NL-18-0086

Vogtle Electric Generating Plant – Units 1&2
Systematic Risk-Informed Assessment of Debris Technical Report SNC Response to NRC Request for
Additional Information (RAIs #16-36)

**Vogtle Electric Generating Plant - Units 1 & 2
Systematic Risk-Informed Assessment of Debris Technical Report SNC Response to NRC
Request for Additional Information (RAIs #16-36)**

Figure 16-1: Head Loss across the RHRA Strainer (Weld 11201-003-5-RB, 19-inch partial break)

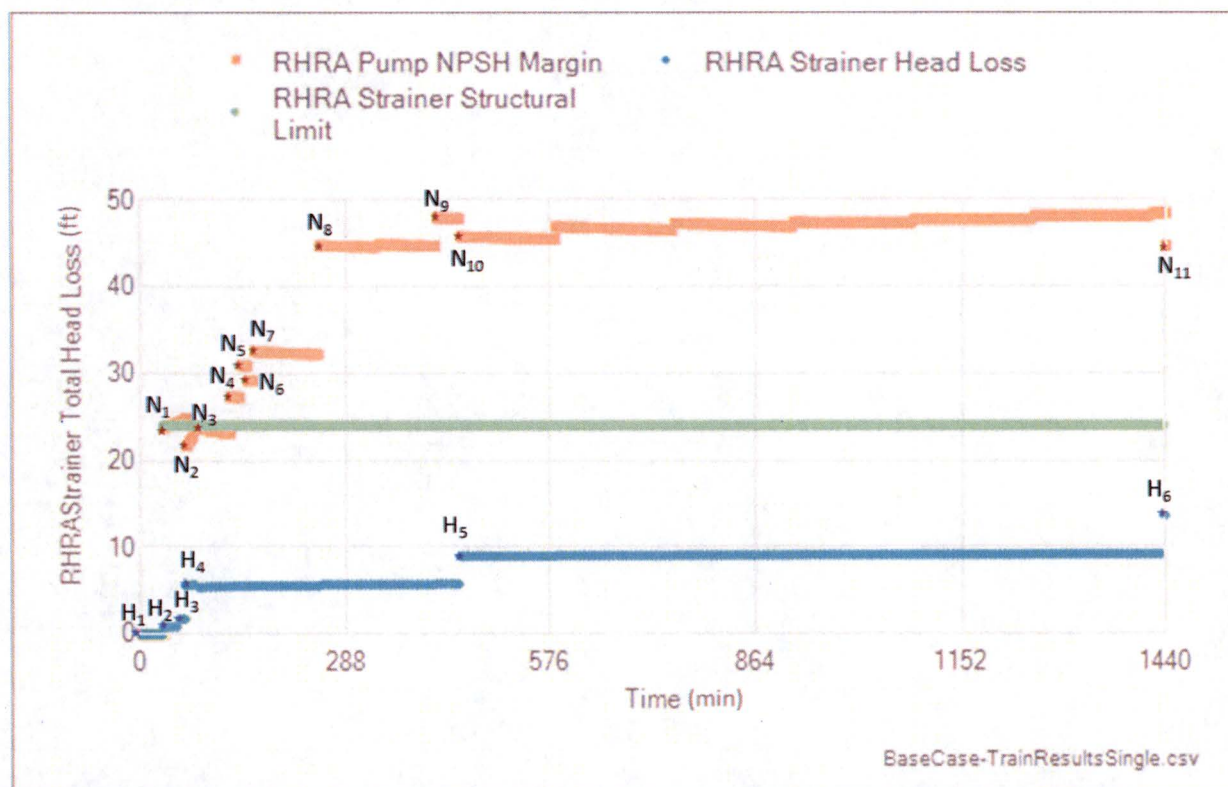
Enclosure 3, Section 9.0 states that debris is assumed to arrive at the strainers as a function of pool turnover time that changes the relative accumulation of debris on strainers, depending on the operating alignments and run time of pumps taking suction from the pool. Section 10.1 states that head losses are applied using a rule-based approach based on the amount of fiber on the strainer. Please confirm that head loss is applied at each time step as follows:

- a. If there is any debris on the strainer, but it is less than 0.45 inches theoretical thickness, the thin bed head loss is applied.
- b. If the debris bed has a theoretical thickness of greater than 0.45 inches, the calcium phosphate head loss is added to the total.

- c. If the debris bed is greater than 32.04 cubic feet (0.57 inches) per residual heat removal (RHR) strainer, the full load head loss is applied in place of the thin bed head loss, and appropriate chemical effects adders are applied.

- d. If the amount of aluminum in solution reaches the calculated saturation limit or at 24 hours, whichever occurs first, the sodium aluminum silicate head loss is added to the total.

- e. The extrapolation value is added to the head loss at 7.5 hours.
- f. The head loss is corrected for flow and temperature (difference from test flow velocity and temperature) at each time step. The head loss correction used is the greater of that derived from the thin bed or full load test for the conditions that exist at the time step being evaluated.

- g. When there is flow through the strainer, the clean strainer head loss is added at every time step.

Please confirm that this description of the head loss model is correct. If the description is not correct, please provide a revised description, including a graphical representation of the head loss response to changes in the various model parameters.

The description above is accurate. However, it should be noted that the volume of debris required to transition from the thin bed head loss to the full load head loss (see Part c above) is dependent on the effective strainer area. The strainer area is adjusted to account for the contribution of miscellaneous debris [Ref. 1, p. E3-20] and brief periods of time when the strainer is not fully submerged for some reactor cavity breaks [Ref. 1, p. E3-18]. Therefore, the debris volume required to form a 0.57-inch thick

bed is scaled down based on the reduced strainer surface area, and the full load test head loss is applied for a fiber debris quantity less than 32.04 ft³.

Figure 16-1 illustrates the time-dependent changes in head loss and NPSH margin for a specific break based on the methodology described above.

The following significant changes in head loss are noted:

- H₁: There is no strainer head loss when the RHR pumps are drawing from the refueling water storage tank (RWST).
- H₂: When the RHR pumps switch over to sump recirculation, the clean strainer head loss is applied [Ref. 1, p. E5-81]. Also, with the initial arrival of debris on the strainer, the conventional debris head loss from the thin-bed test is added [Ref. 1, p. E5-82] and corrected for the pool temperature and strainer approach velocity [Ref. 1, pp. E5-77 to E5-80].

- H₃: As debris continues to accumulate on the strainer and the bed thickness exceeds 0.45 inches, the calcium phosphate head loss is applied [Ref. 1, p. E5-82] and corrected for the pool temperature and strainer approach velocity [Ref. 1, pp. E5-77 to E5-80].

- H₄: When the fiber debris load on the strainer exceeds the quantity tested in the thin-bed test, the conventional head loss is changed from the thin-bed test to the full load test [Ref. 1, p. E5-82] and corrected for the pool temperature and strainer approach velocity [Ref. 1, pp. E5-77 to E5-80].

- H₅: At 7.5 hours following the start of the event, the 30-day head loss extrapolation constant is added to the total head loss [Ref. 1, pp. E5-80 to E5-81] and corrected for the pool temperature and strainer approach velocity [Ref. 1, pp. E5-77 to E5-80].
- H₆: At 24 hours following the start of the event, aluminum precipitation is forced [Ref. 1, p. E5-153]. At this point, the sodium aluminum silicate head loss is applied [Ref. 1, p. E5-82] and corrected for the pool temperature and strainer approach velocity [Ref. 1, pp. E5-77 to E5-80].

Note that there are several fluctuations in the RHR pump net positive suction head (NPSH) margin over the course of the event as shown in Figure 16-1. The following significant changes in NPSH margin are noted:

Figure 20-1: NARWHAL connection between compartment objects

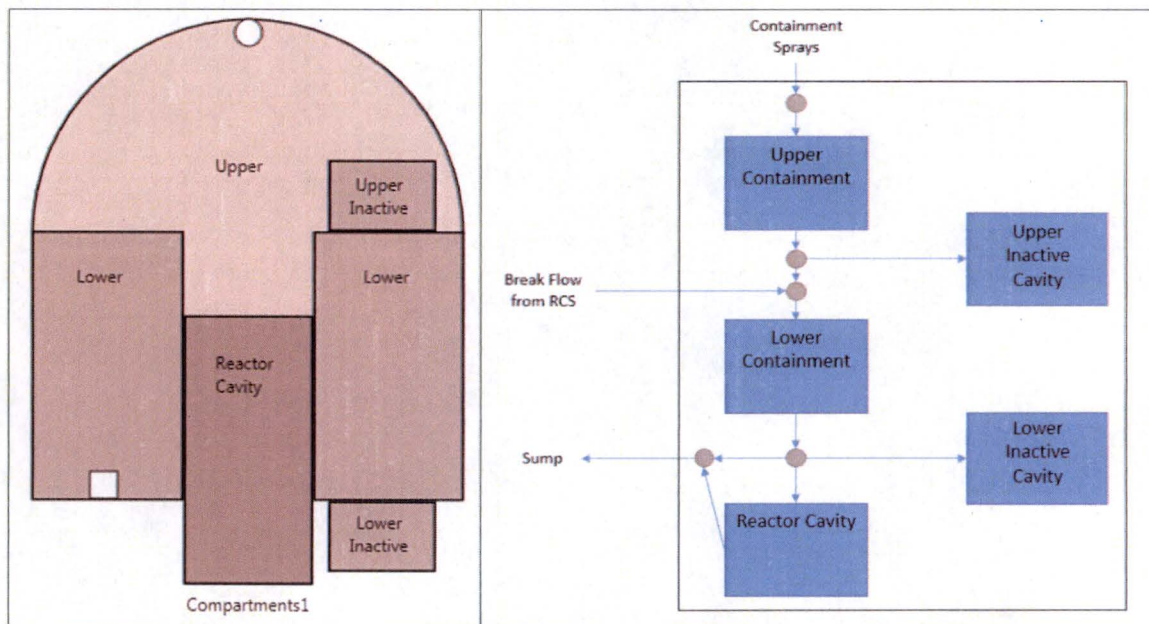
- a. Please provide a simplified high-level description of the NARWHAL debris transport and distribution models, including a description of how the debris transport fractions from the CFD model, blowdown analysis, and other portions of the transport analysis are incorporated into the final transport values for debris to each strainer. Please describe of which values are inputs to the transport logic trees, which tables are outputs of the transport logic trees, and how the "overall" transport values are treated based on the pump operating states.

- a. In NARWHAL, the fraction of debris that transports to various compartments and strainers is calculated based on user-defined blowdown, washdown, pool fill, and recirculation transport fractions. As shown in Figure 20-1, NARWHAL contains a set group of compartment objects. Since the representation of compartments is fixed, the locations where debris is distributed at the beginning of the event can be calculated with a generic set of equations.

Figure 21-1: Comparison between predicted fiber penetration quantities and test results

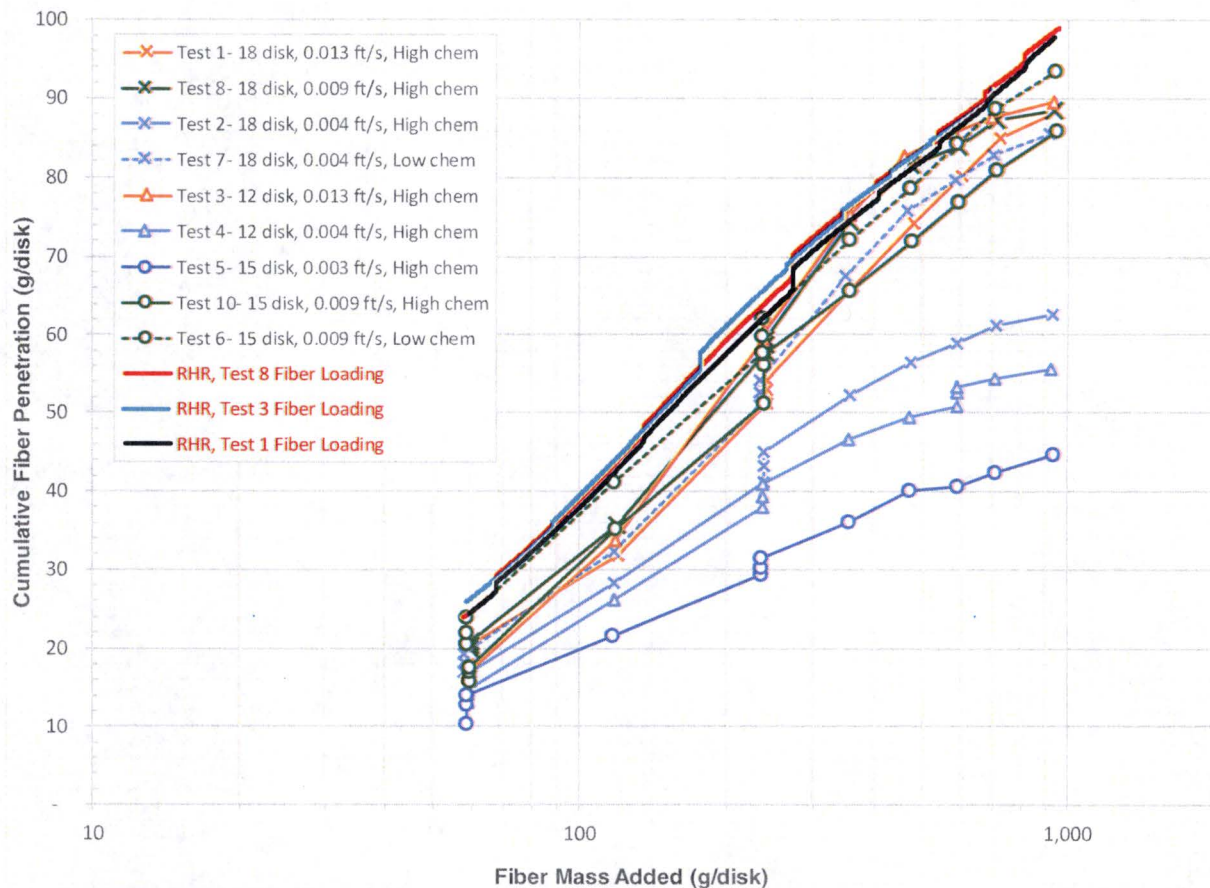
For the fiber mass balance, please confirm the adequacy of the penetration model from the information provided in the submittal. Also, please confirm that the filtration and shedding functions included in the mass balance model were compared to the test data using the final set of parameters for NARWHAL calculations.

- a. Is the penetration amount based on the total amount of fiber or only the fine fiber arriving at the strainer?
- b. Please provide a comparison of the equation predictions with the test data using the parameters for NARWHAL calculations.

- b. Fiber penetration models were derived for the RHR and CS strainers and their respective operating conditions using the VEGP fiber penetration test data from 9 different tests. As stated in the Response to 3.n.1 in Enclosure 5 of the VEGP submittal, the resulting RHR penetration model predicts higher fiber penetration quantities than all of the actual tests because of the high strainer approach velocity and low chemistry conditions of the RHR strainer, as demonstrated in Figure 3.n.1-3 of Enclosure 5 in the VEGP submittal [Ref. 1, p. E5-139].

Figure 21-1 shows another comparison between the predicted fiber penetration quantities using the RHR strainer penetration model and the testing results. In the figure, the cumulative fiber penetration quantities are plotted as functions of the quantity of fiber added to the test tank. All debris quantities shown in the figure are normalized by the number of strainer disks. The RHR penetration model was applied to the plant RHR strainer approach velocity and disk number, along with the debris addition sequence of Test 1, Test 3, and Test 8 (e.g., debris introduction timing, duration and quantity). The results are shown in the figure as the thick solid lines. The measured fiber penetration quantities are shown for all 9 tests as the thin solid lines, identified by different markers. As shown in the figure, the predicted fiber penetration quantities for each test bound the measured data points of the corresponding test. Therefore, applying the fiber penetration model is conservative for quantifying fiber penetration for the evaluation of in-vessel downstream effects.

Figure 26-1: Distribution of small piece debris washed down from upper containment

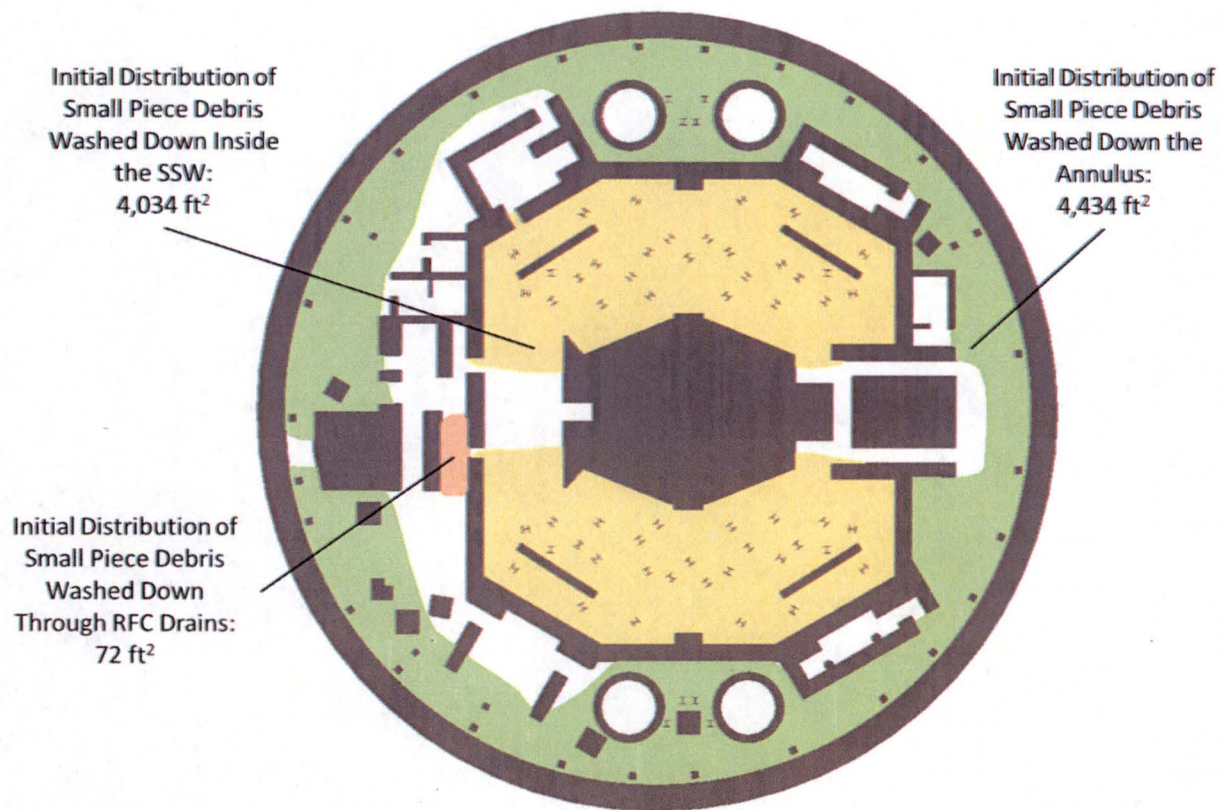
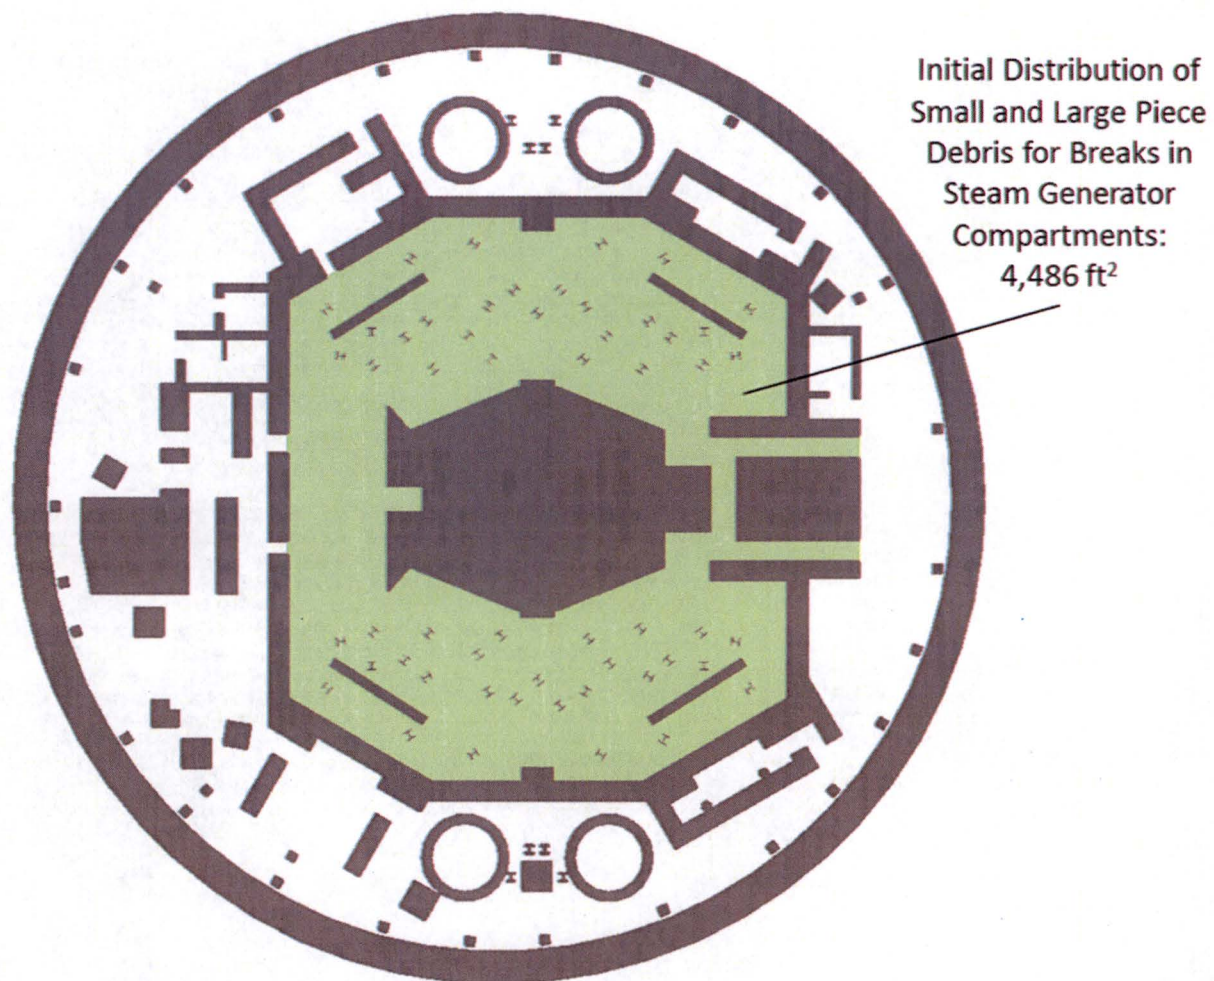
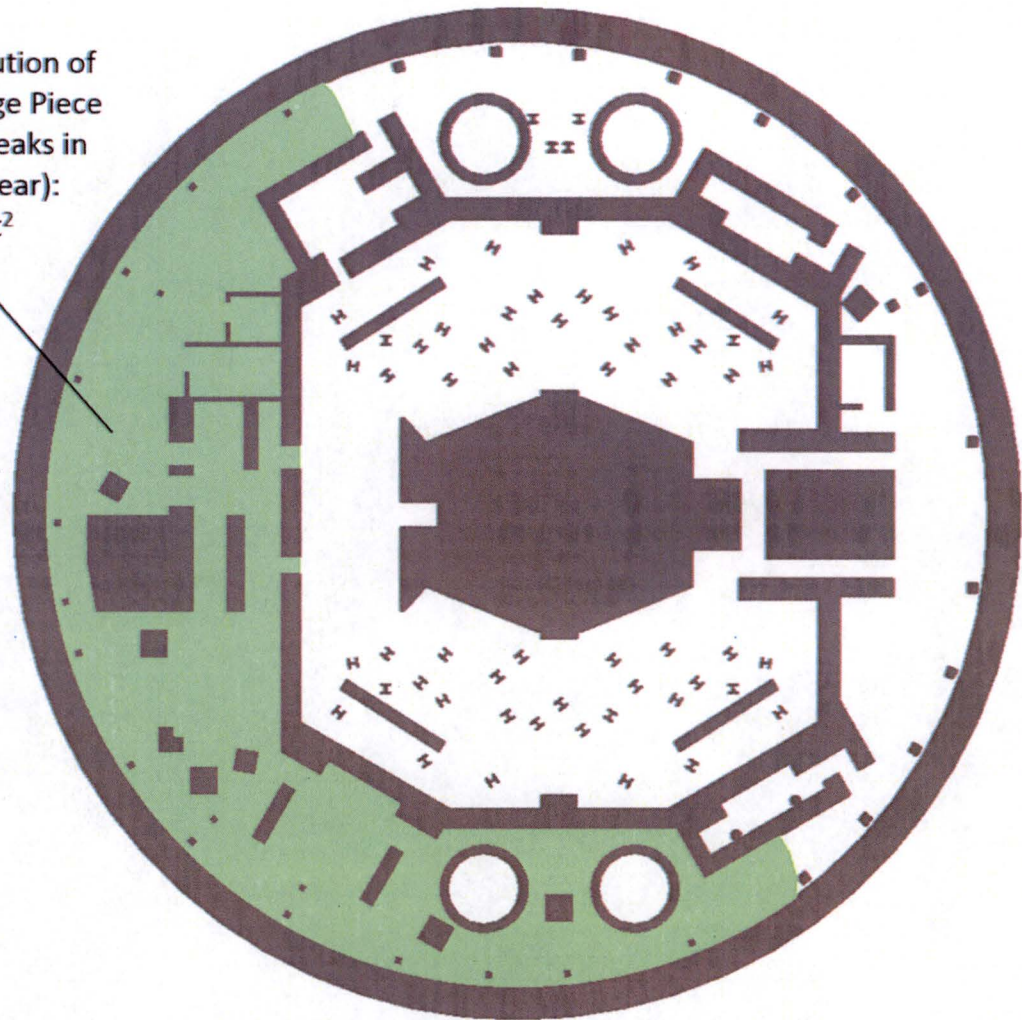
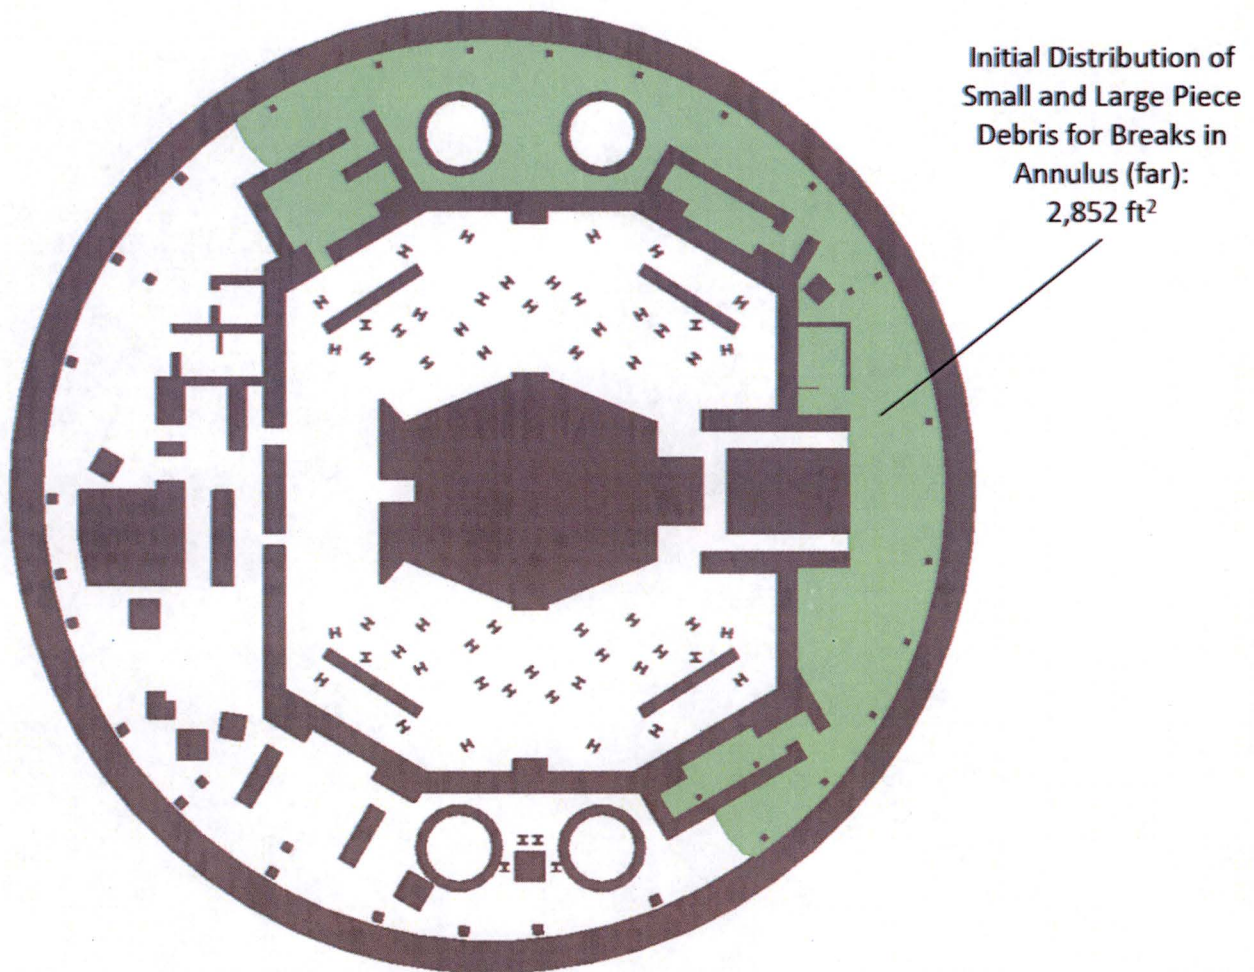
- a. Please describe how debris locations at the start of recirculation were determined, including the effects of blowdown, pool fill, and washdown. If some of the effects are not accounted for in the model, please describe how the evaluation ensures that the model is conservative. Alternatively, please confirm that risk is not underestimated.
- b. Please describe which recirculation transport cases from Tables 3.e.6-4 through 3.e.6-6 were applied to corresponding break location cases.
- c. Please clarify whether the CFD results used in the transport analysis were steady state values input at the start of the recirculation transport or if the values were changing based on stagnant conditions at the start of recirculation.

Figure 26-1 through Figure 26-4 graphically depict the initial debris distribution areas for the various types/sizes of debris. Figure 26-1 shows the distribution area of small piece debris washed down from upper containment to the steam generator compartments inside the secondary shield wall (SSW), through the refueling canal (RFC) drain, and to the annulus. Figure 26-2 shows the distribution area for small and large piece debris for breaks in the steam generator compartments. Figure 26-3 and Figure 26-4 show the distribution area for small and large piece debris for breaks in the annulus near and far from the sump strainers, respectively.
